New Project Proposal: SFF-TA-1026

Presented: March 14th, 2025

Presenter: Egide Murisa, Molex LLC

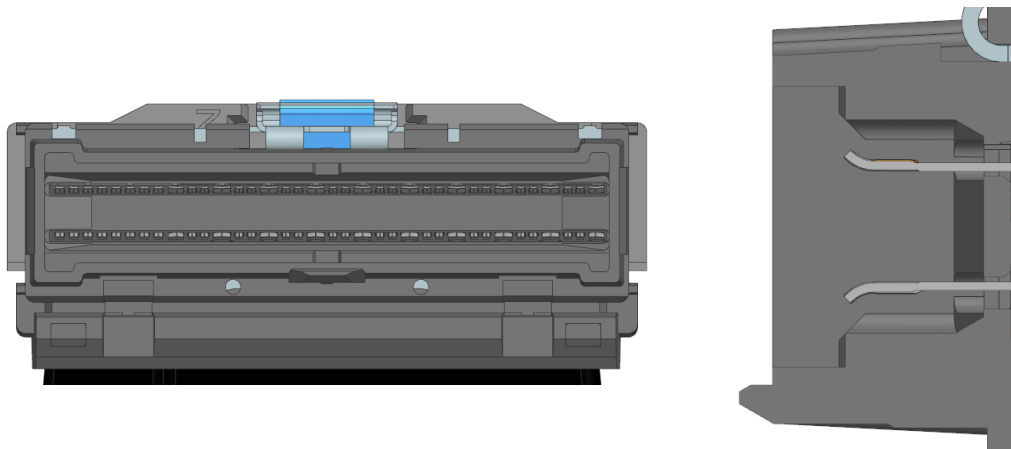
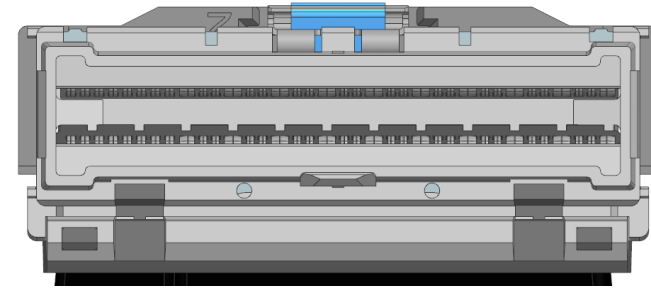
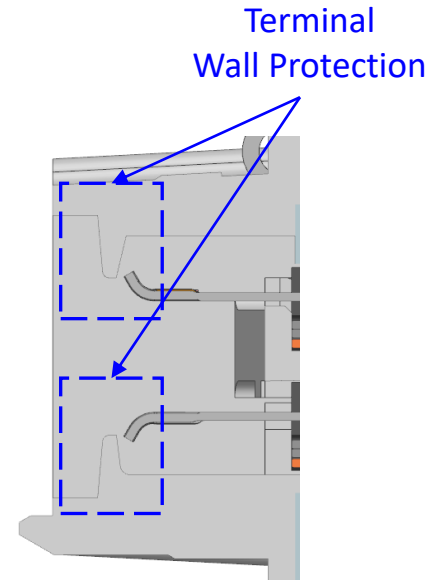
- Added features on the connector and the cable for the connector pin protection. The mating interface is not backward compatible to the legacy connector variants.
- Additional editorial changes will be made.
- Editor(s): Egide Murisa
- Supporters:
 1. Egide Murisa, Molex LLC
 2. Michael Gregoire, Dell
 3. Howard Andrews, Lotes

- Added support bar to the connector for pin protection

- Updates:
 - Added plastic shield to the cable for pin protection
